ADDENDUM

ADDENDUM NO.: 04
PROJECT NAME: Salt Dome Replacement Facility (Grand Avenue)
PROJECT NO.: 04021
CONTRACT NO.: C1598
DATE OF ISSUE: January 27, 2021

NOTICE OF CHANGES, MODIFICATIONS, OR CLARIFICATIONS TO CONTRACT DOCUMENTS

E1.2

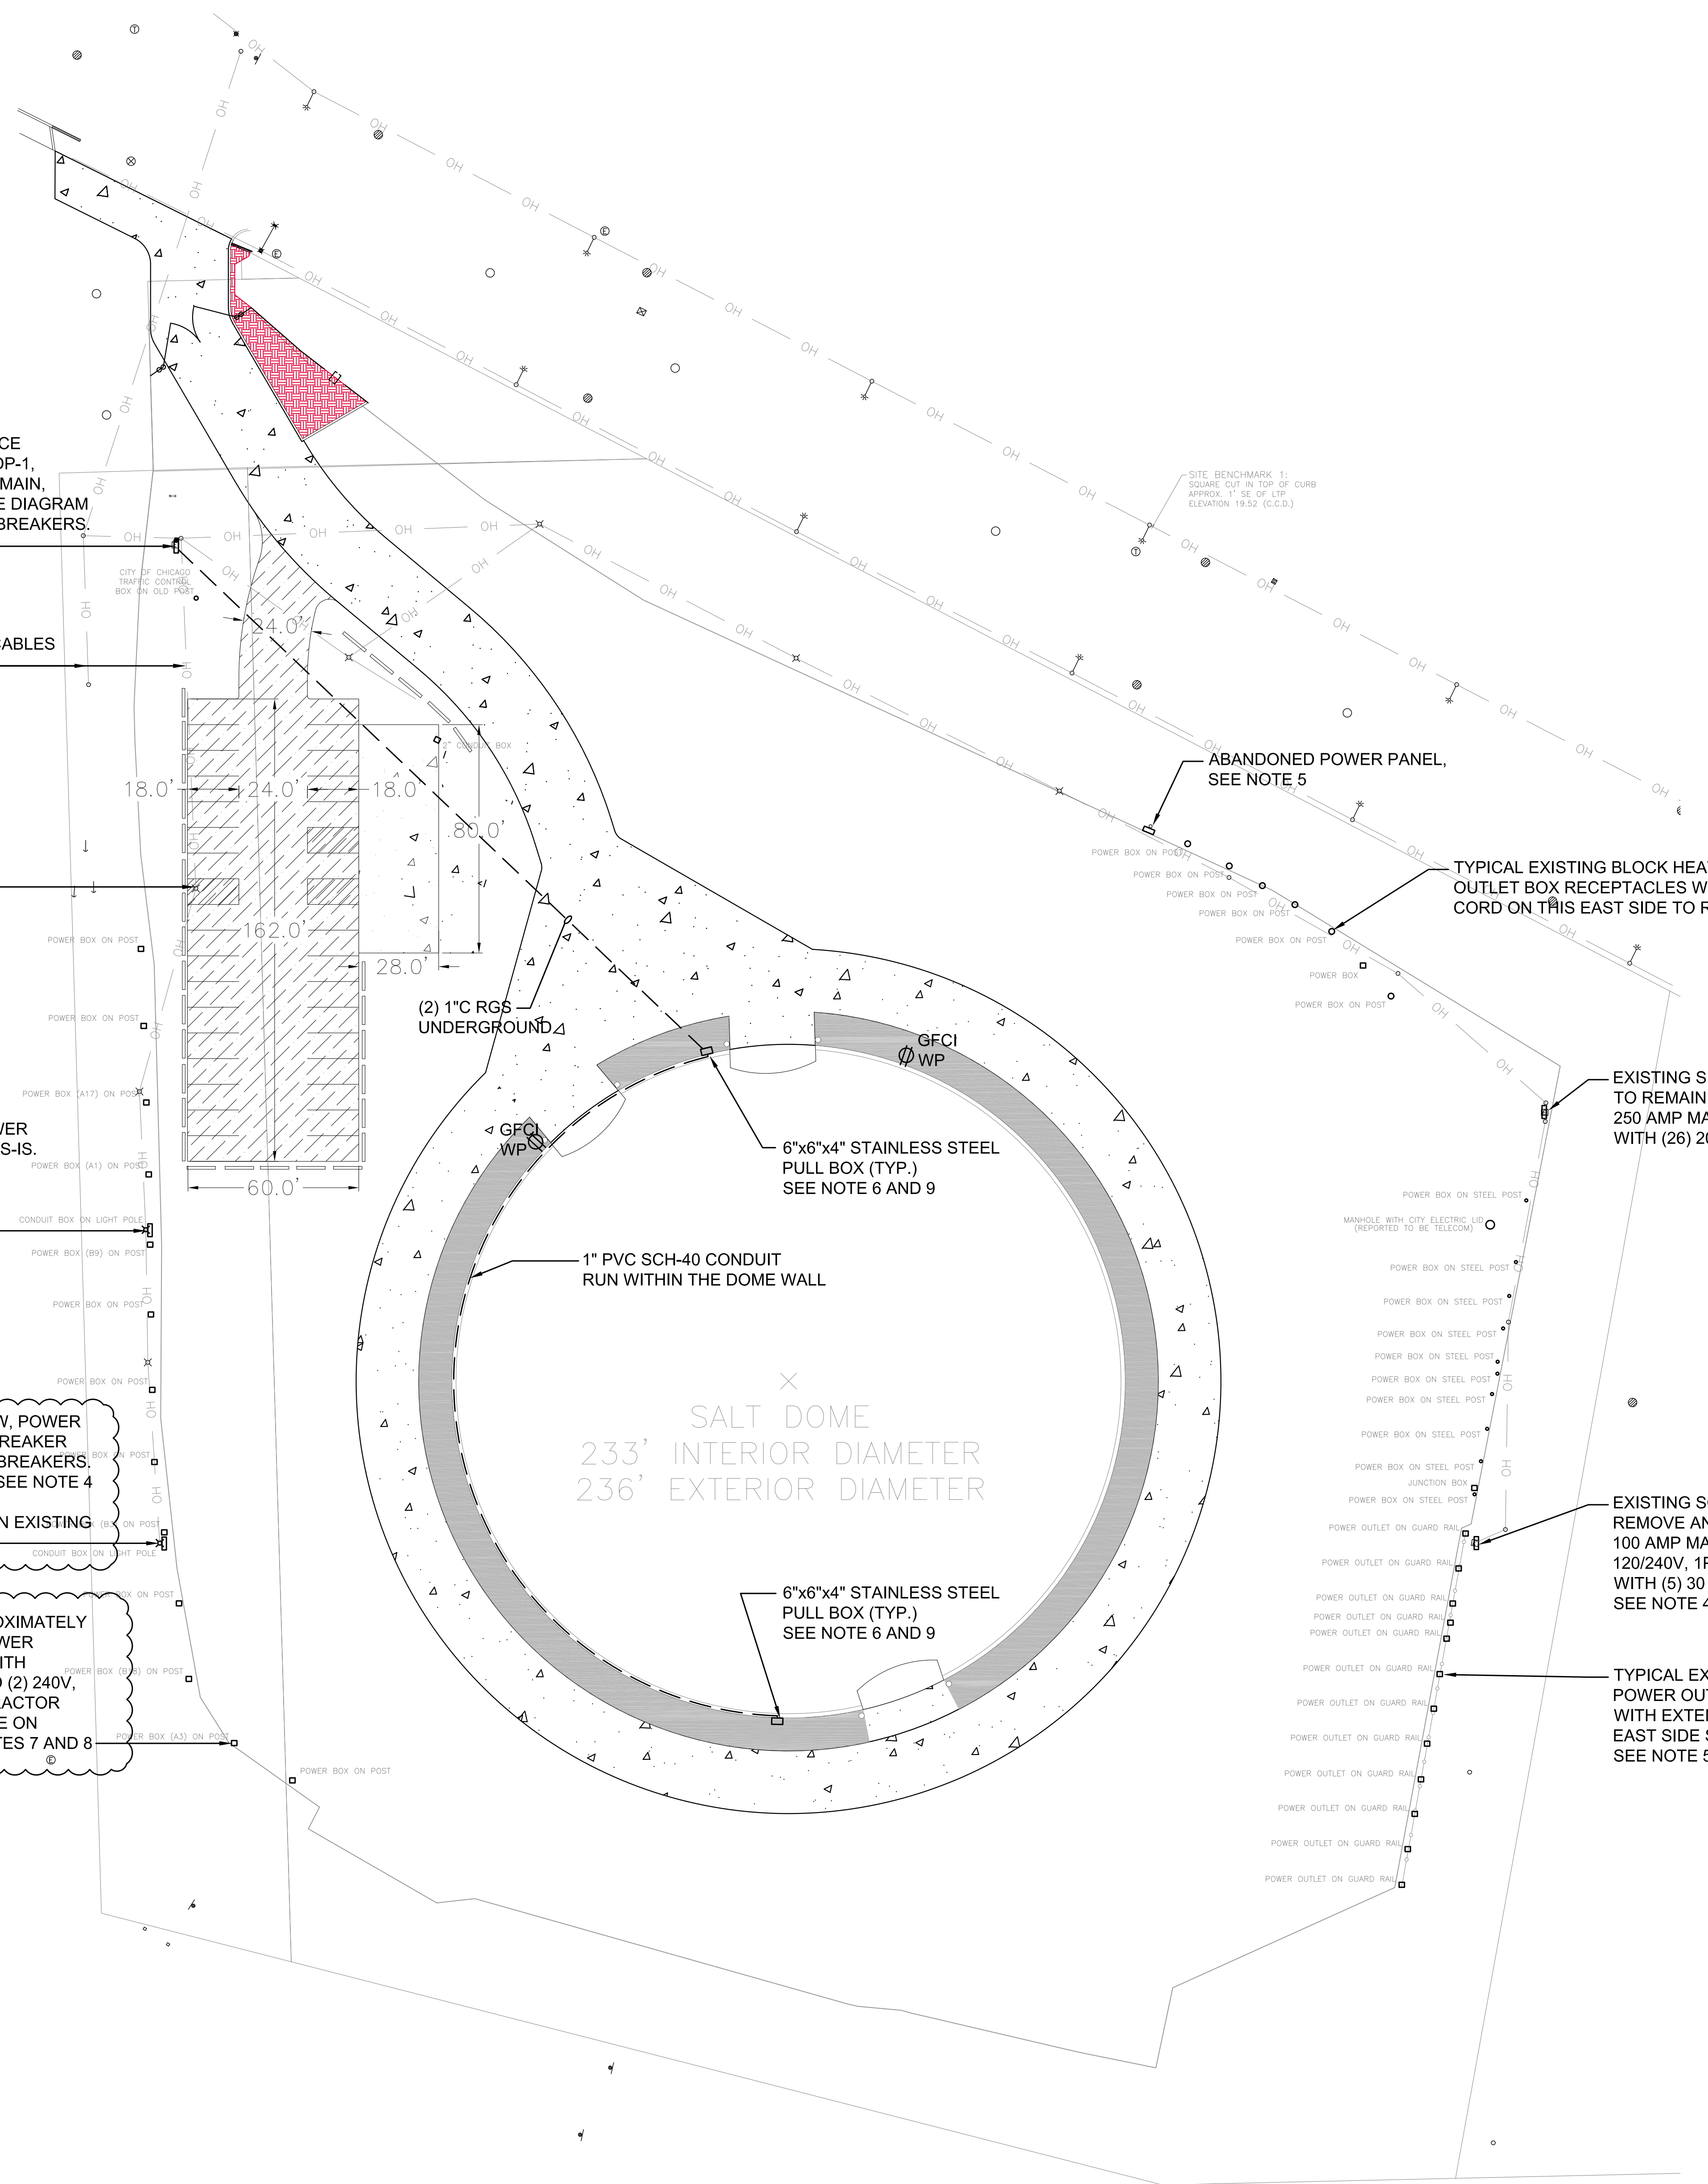
Change 5 **REVISED** Drawing No. E1.2, Site Power Plan: Note 8 and relevant callouts revised for clarity. Sheet scale fixed.

Question: (Electrical E1.2) Per the note regarding the “Yellow Boxes”, page E1.2, is electrical to simply “rotate the boxes to face WEST, or is there more to this relocation effort? Where are the existing boxes currently? The note is slightly ominous in its projection of the work effort, please advise.

Question: (Electrical E1.2) Is Note # 8, Drawing E1.2 referring to the “Yellow Boxes”? See below.
8. CONTRACTOR TO REPLACE HUBBELL POWER BOXES, DETAIL "C" AND "D" WITH APPLETON UNILET SINGLE COVER FOR GFCI FSCD BOX. PROVIDE COMPLETE ASSEMBLY 240V, 20AMP DISCONNECT SWITCH, NEMA 6-20R CONFIGURATION RECEPTACLE AND PLUG AND CABLE ASSEMBLY WITH FEMALE PLUG, FOR EACH HUBBELL POWER BOX, CONTRACTOR TO INSTALL TWO APPLETON UNILET FSCD BOXES, SEE DETAILS "E" AND "F" ON SHEET E1.3.

- There are discrepancies with the notes on E1.2. Please confirm the scope of work with all Hubbell boxes on the east side of the salt dome.
- Please clarify the correct spaces in the 100A panels to be replaced. (30? 42?)
- Please clarify if the 30A breakers requested on the print are single pole or 2 pole.

Question: Reference: Electrical - There is a note on the lower left corner of E1.2 that says we are to replace 13 Hubbell 240V Power Boxes with 2 pole breakers. It looks like Note 7 and 8 apply to this replacement. Note 8 refers to E1.3 Detail E, which shows a 120V device. Is the intent to replace the 240V Hubbell boxes and have them feed 2 Nema 6-20R receptacles mounted similar to E1.3 detail E? Are GFI breakers required in the Hubbell boxes?

Response: Drawing sheet E1.2 has been revised and included in this Addendum. Per Note #8, "Contractor to replace Hubbell Power Boxes, Detail "C" and "D" with Appleton Unilet Single Cover For GFCI FSCD Box".

Response: Drawing sheet E1.2 has been revised and included in this addendum. Note #8 refers to the yellow boxes as shown in Details "C" and "D".

Response: Drawing E1.2 has been revised and included in this addendum -A total of 13 Hubbell boxes are being replaced on the WEST side of the dome as shown on Sheet E1.2. None are being replaced on the east side of the dome.

Response: Drawing Sheet E1.2 note #8 has been revised and included in this addendum to clarify the design intent. Hubbell boxes should be replaced with Appleton unilet cover FSCD box, completely assembled (2) 240V 30amp breakers or disconnect switch and NEMA 6-30R configuration, 30A GFI receptacle plug and cable assembly. Note 7 and 8 have been revised and apply to this replacement. Detail E on sheet 1.3 is shown for reference only.

104 TYPICAL ANCHOR BOLT CONFIGURATION
104-510190

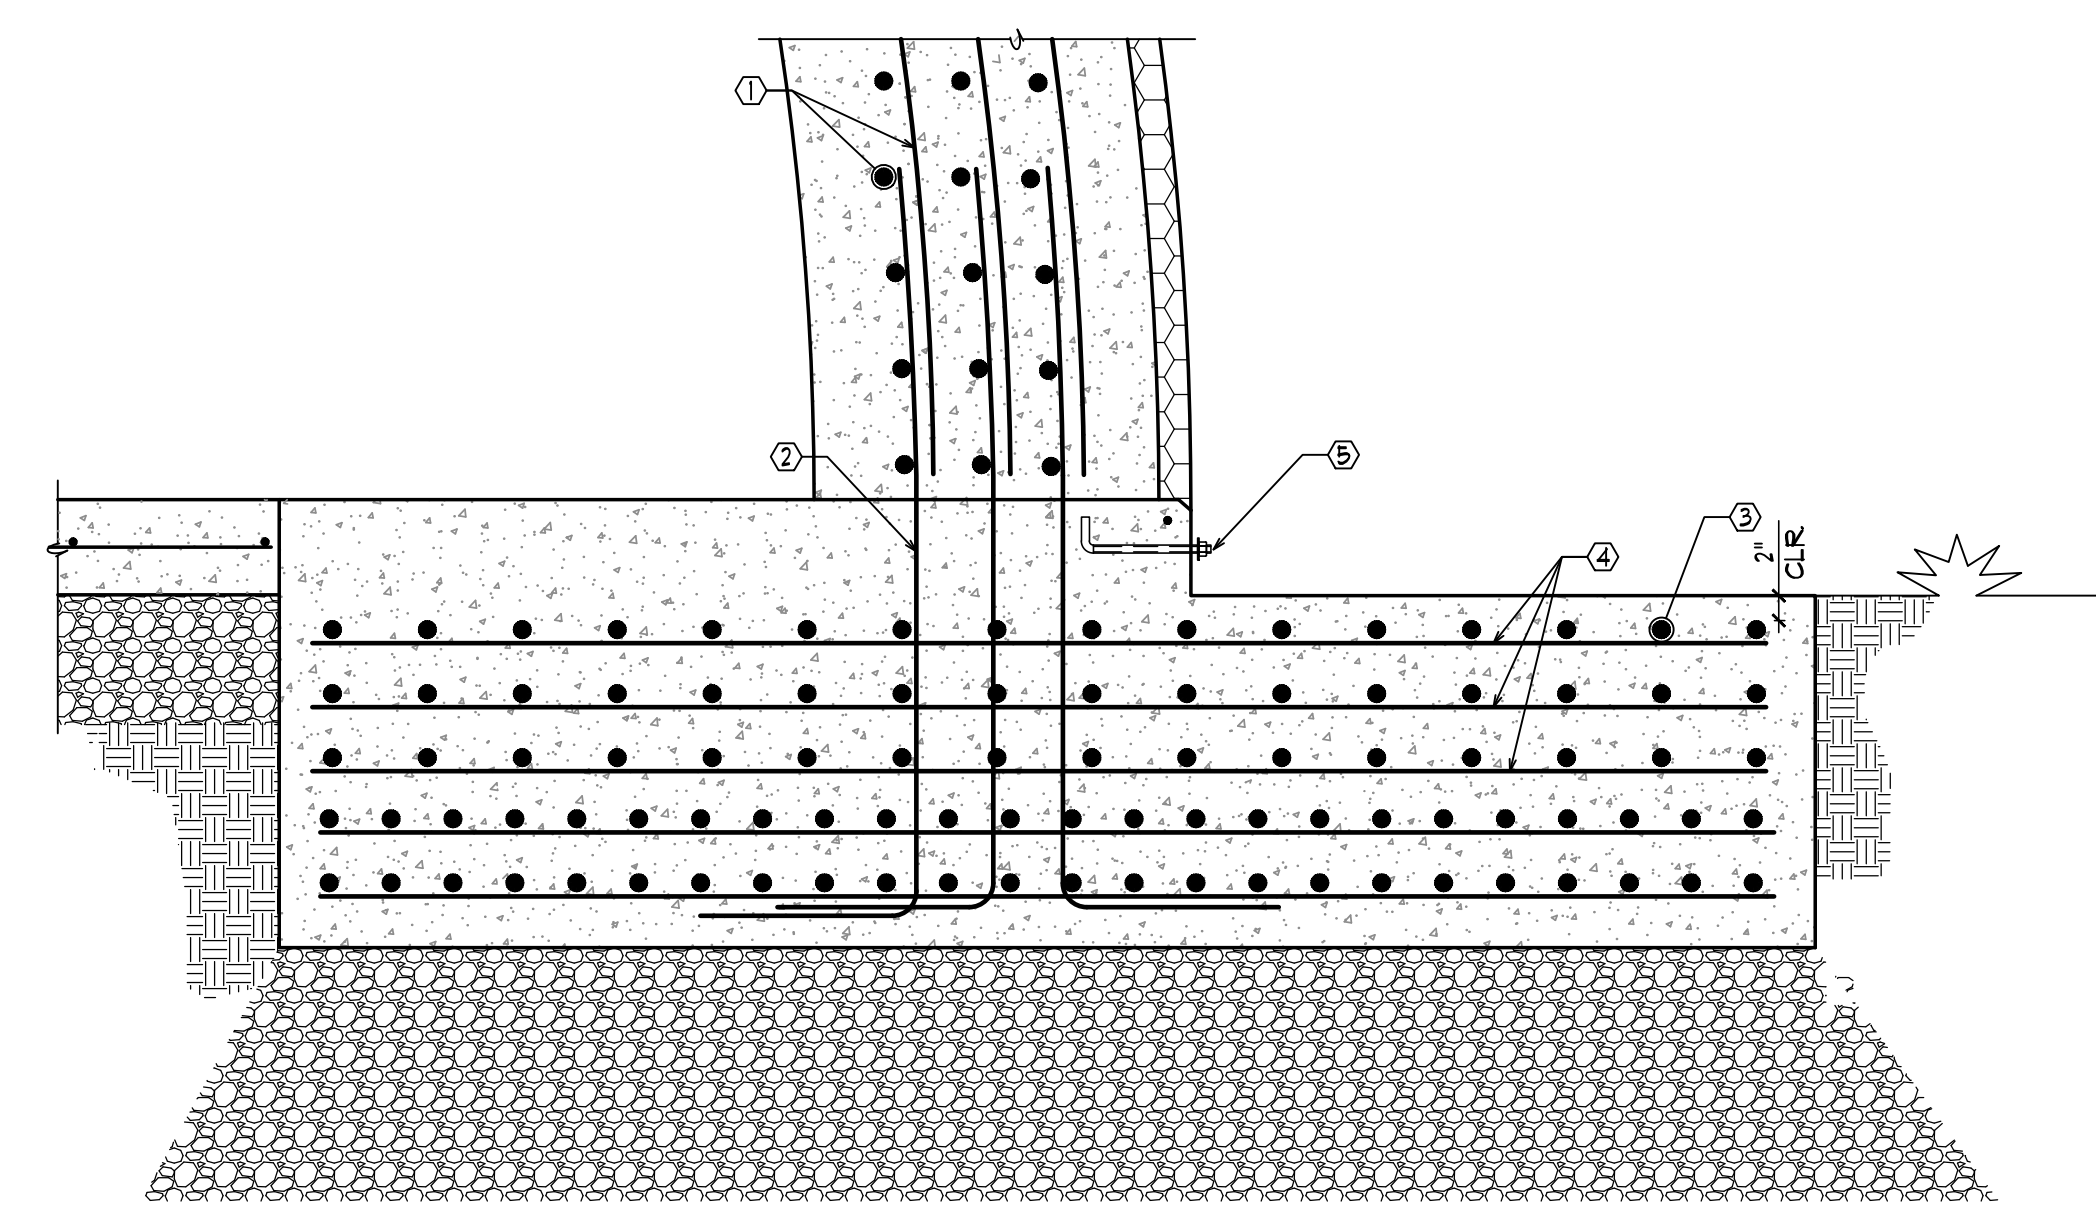
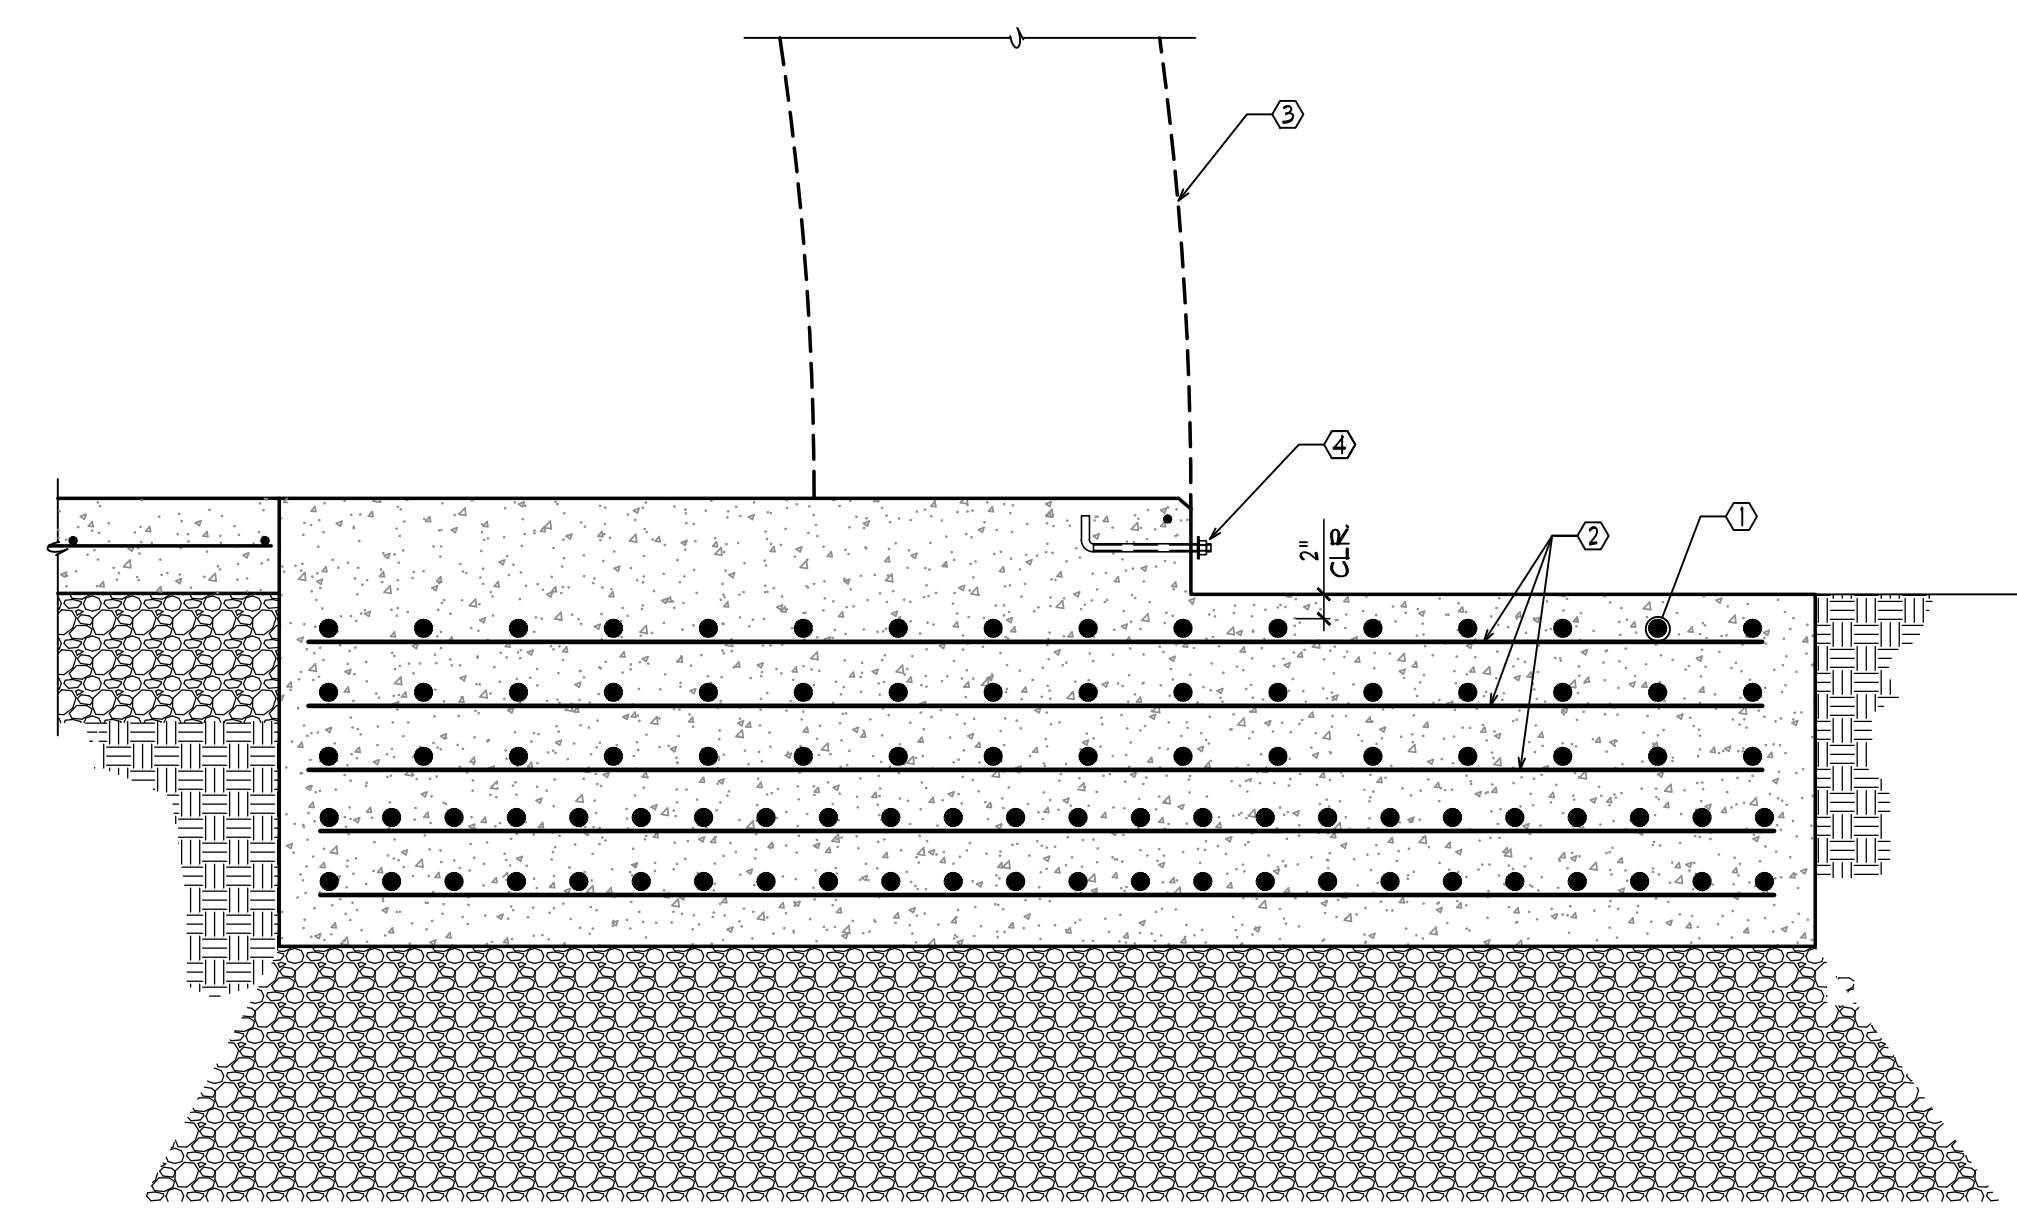
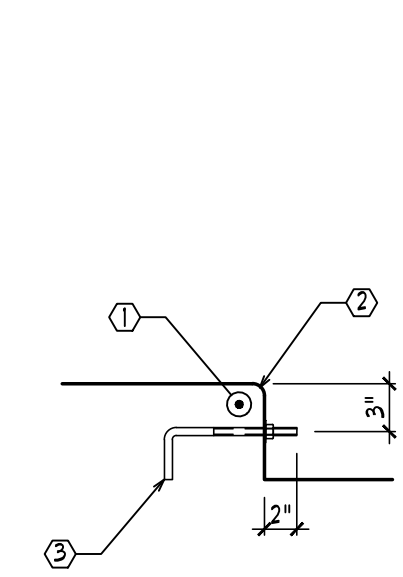
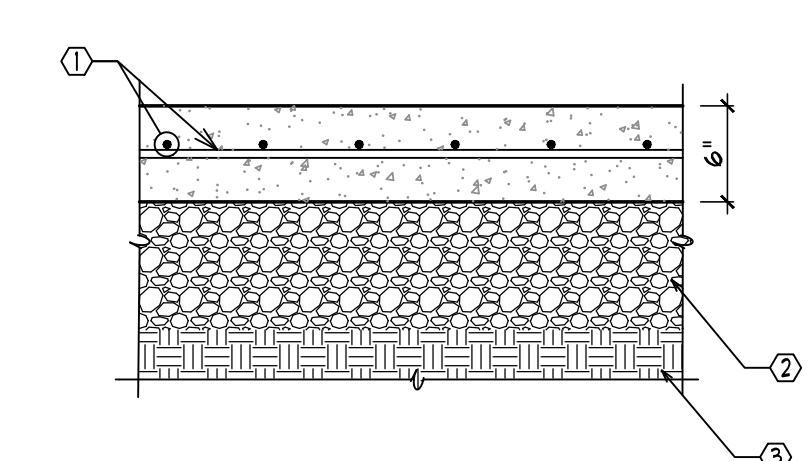
Change 7 **REVISED** Drawing No. S3.1, Details: Detail 105 revised to update floor slab subbase design. Details 101, 102, and 103 revised to properly identify anchor bolt details.

Question: Foundation details 101, 102 & 103 on sheet S3.1 show an anchor bolt located on the exterior side of the foundation. Please provide information on type, size and spacing of the anchor bolt shown..

Response: Drawing Sheet S3.1 has been revised and included in this Addendum to identify the anchor bolt type, size, and spacing are shown in detail 104.
